**BELL BEND NUCLEAR POWER PLANT
DATA TO SUPPORT THE
WALKER RUN CLOMR REQUEST
BNP-2012-070 Docket No. 52-039**

Reference: 1) Case No.: 12-03-0820R
Walker Run
Community: Township of Salem, PA
Community No.: 420625

Bell Bend Nuclear Power Plant Flood Study Report Walker Run

Walker Run Flood Study Report

SHEET TITLE: FLOODPLAIN MAP
FLOOD STUDY - WALKER RUN
SALISBURY TOWNSHIP
LUZERNE COUNTY, PENNSYLVANIA

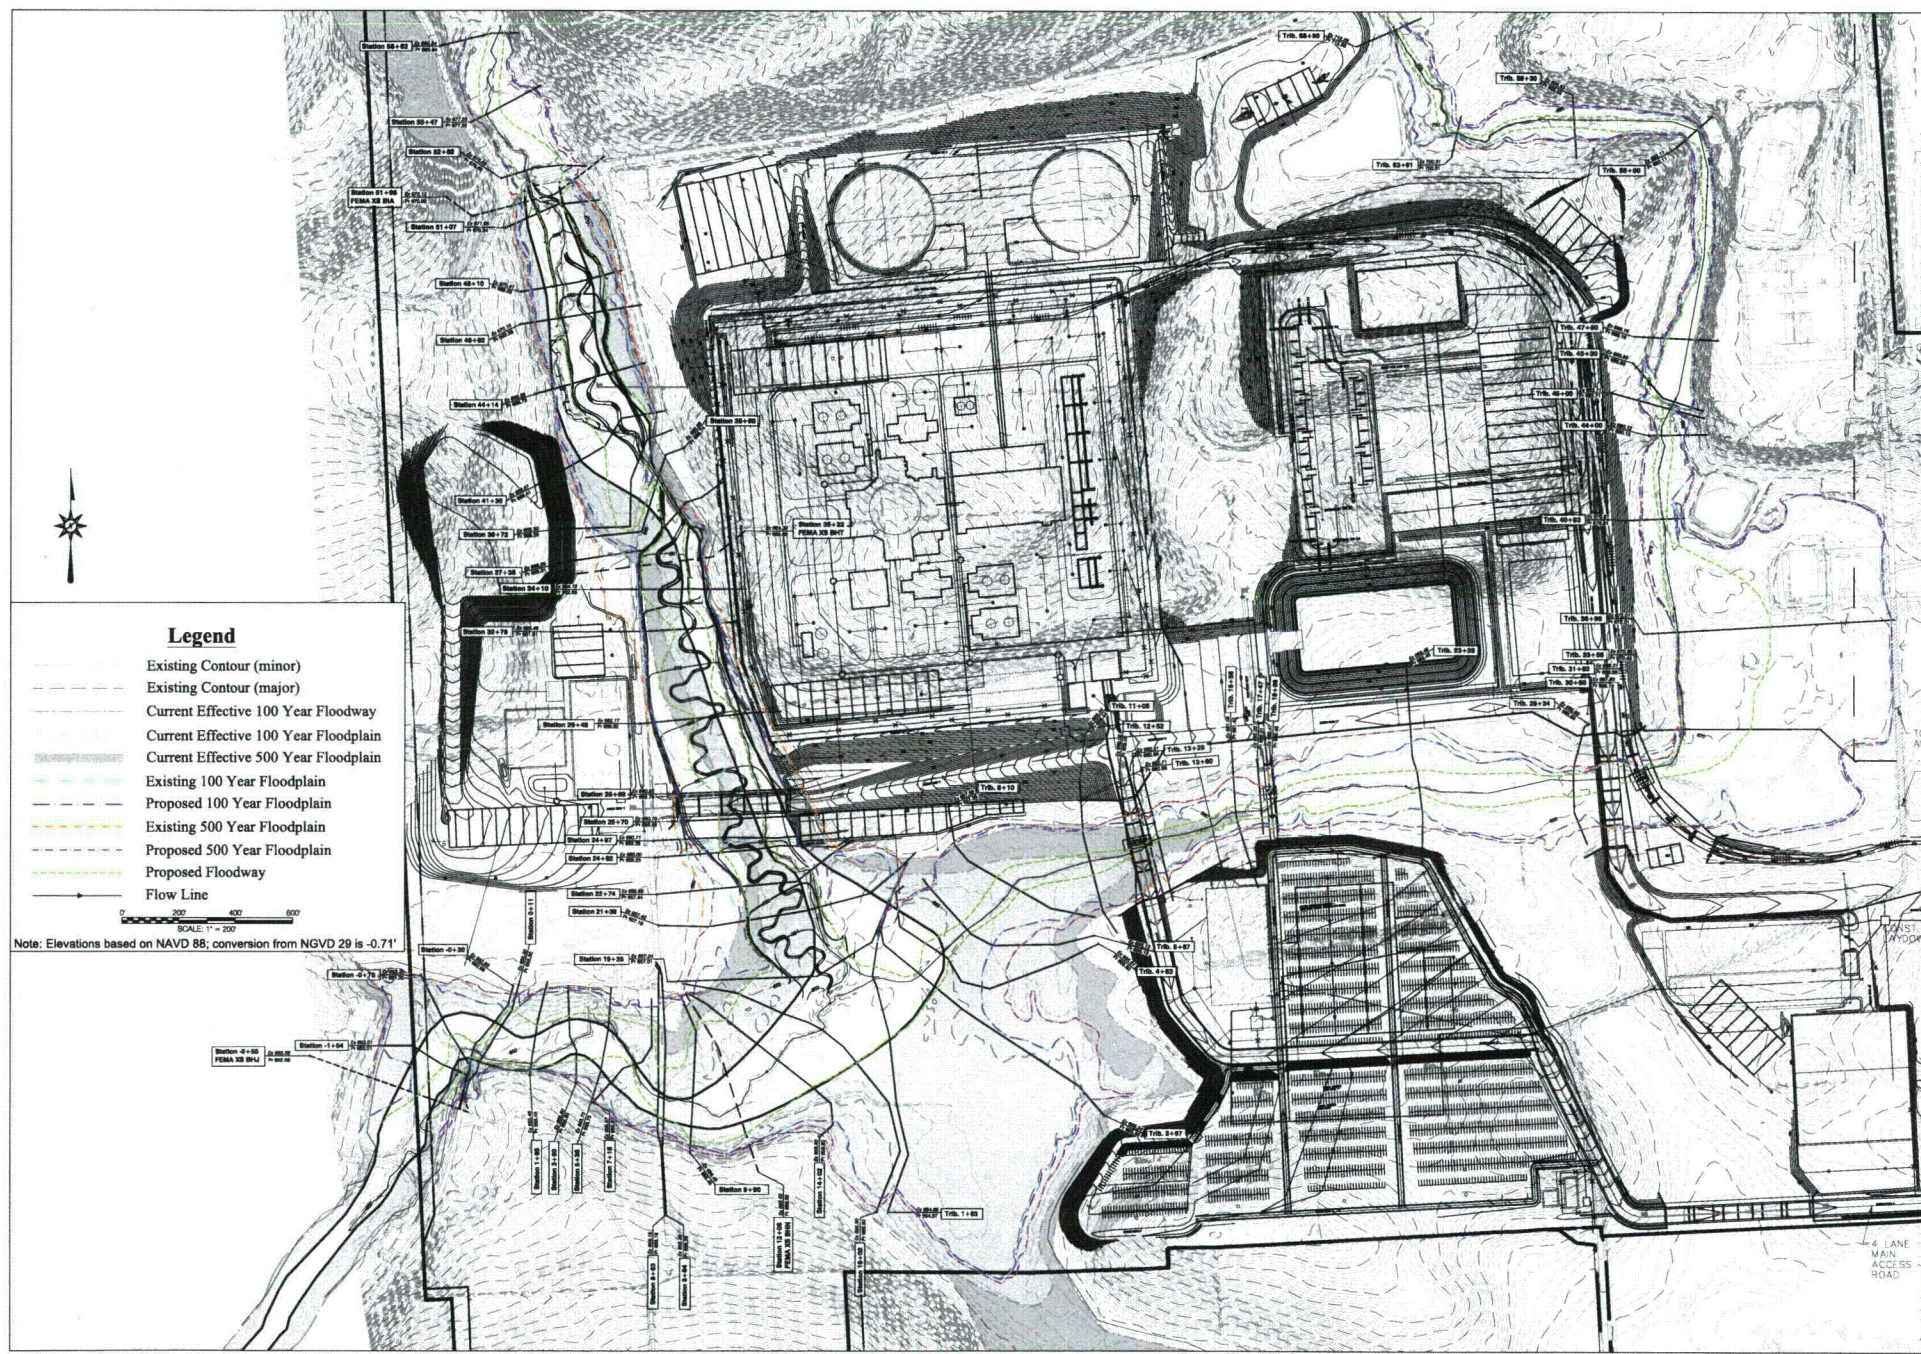
4. Our review of the submitted work map, entitled "Floodplain Map Flood Study – Walker Run," prepared by Land Studies and last revised date December 15, 2011, revealed the following issues. Please submit a revised topographic work map, certified by a registered Professional Engineer, that shows all applicable items listed in Section C of Application/Certification Form 2, entitled "Riverine Hydrology and Hydraulics Form," including the following information:

a. FEMA effective study cross-sections are crossing with other added cross-sections at

several locations within the base floodplain for Walker Run. Please re-orient the cross-sections such that the cross-sections do not cross each other within the base floodplain boundary.

b. Some of the proposed structures and roadways in the revision area are not overtopped by the base flood elevations; therefore, the proposed floodplain boundary limits should be shown as being contained within the structures at these locations rather than flowing over them. These structures should be shown outside the proposed floodplain limits. Please trim the floodplain and floodway delineations, just upstream and downstream of these structures, such that the delineations will appear to be contained within the structures.

c. Please ensure that top width of the base floodplain computed in the revised model is delineated correctly in the revised work map.

Based on subsequent discussions with the reviewer, all but four of the cross sections from the current effective model have been removed from the existing and proposed conditions models. The four sections that remain (BHJ, BHN, BHT, and BIA), have been realigned, if necessary, and the geometry has been adjusted based on the existing topography.

The floodplain lines have been revised so that they do not extend over bridges that are not overtopped by the base flood.

The top width of the base floodplain had been checked and is now delineated correctly on the work map.
